ADVANCED MICRODEVICES (PVT.) LTD.

Change Notice No.	Notification date	Implementation date
CN/17/02	10 th January 2017	10 th February 2017

Subject : Improved design of of mdi Funnel (Funnel Base)

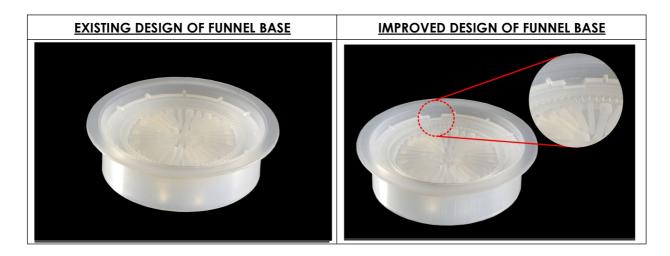
During use of **mdi** Funnel, the membrane is to be cultured with growth medium for incubation. To perform this process step, the membrane assembled in funnel base has to be lifted and transferred to respective growth medium plates to facilitate the growth of microorganism retained on the membrane. It was observed that It is sometimes difficult to lift the membrane from funnel base. To address this observation, design of funnel base of **mdi** Funnel has been improved by providing a groove for easy lifting of membrane. No change has been done in any critical dimensions of the Funnel. The new design of **mdi** Funnel has been verified for critical product performance parameters including fitment with respective components.

From a practical point of view the changes done will improve the ease of use of **mdi** Funnel. All performance specifications, product attributes, materials of construction and fitment with respective components will remain unchanged.
